# TWR-AUDIO-SGTL Tower Module

## Hardware Errata and Changes

Rev. 0.3

## TWR-AUDIO-SGTL\_01 Incorrect Component Values

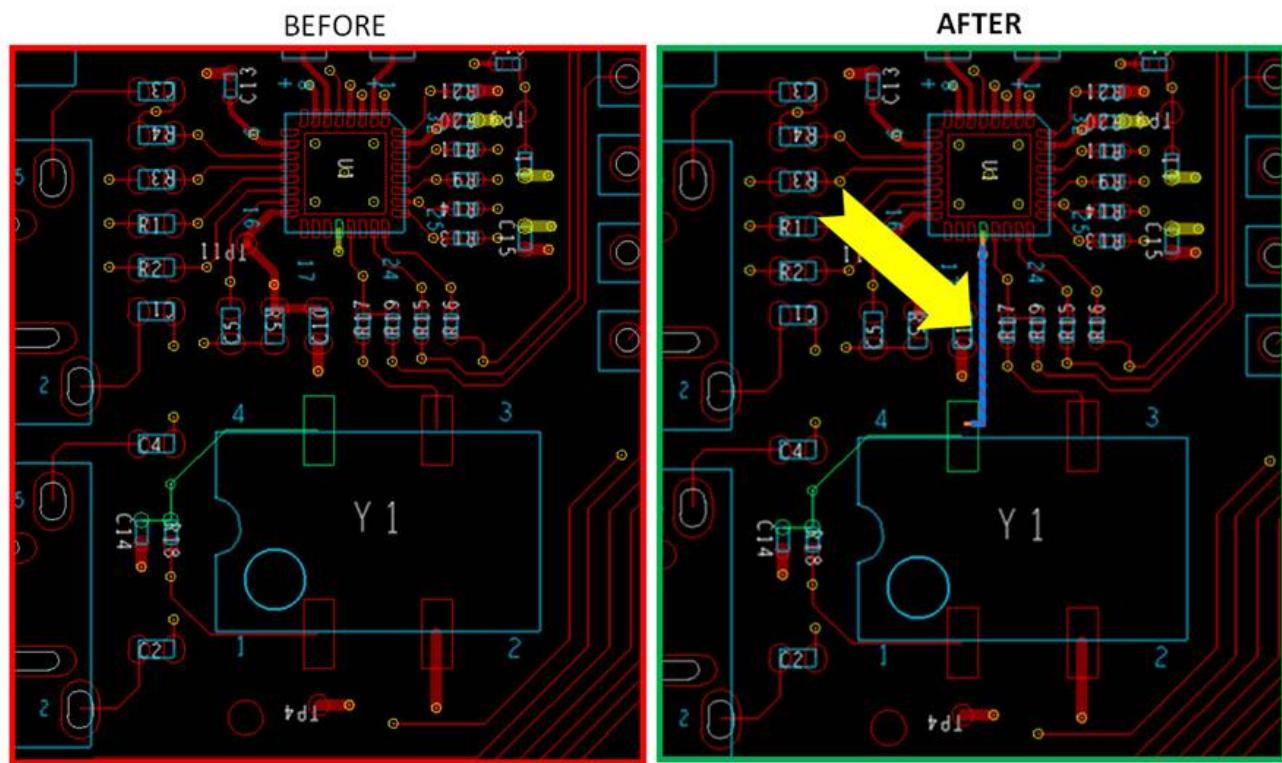
The following components have been changed to correct problems and to install a 24.576MHz quartz oscillator.

Component	Revision B Value	Revision B1 Value
R1	10k Ohm	0 Ohm
R2	10k Ohm	0 Ohm
R3	10k Ohm	0 Ohm
R4	10k Ohm	0 Ohm
C14	0.1 uF DNP	0.1 uF
R18	10k Ohm DNP	10k Ohm
Y1	12.288 MHz DNP	24.576 MHz Ecliptek Corporation EH15 00 SJ TS – 24.576
R19	0 Ohm	0 Ohm DNP
R43	0 Ohm	0 Ohm DNP
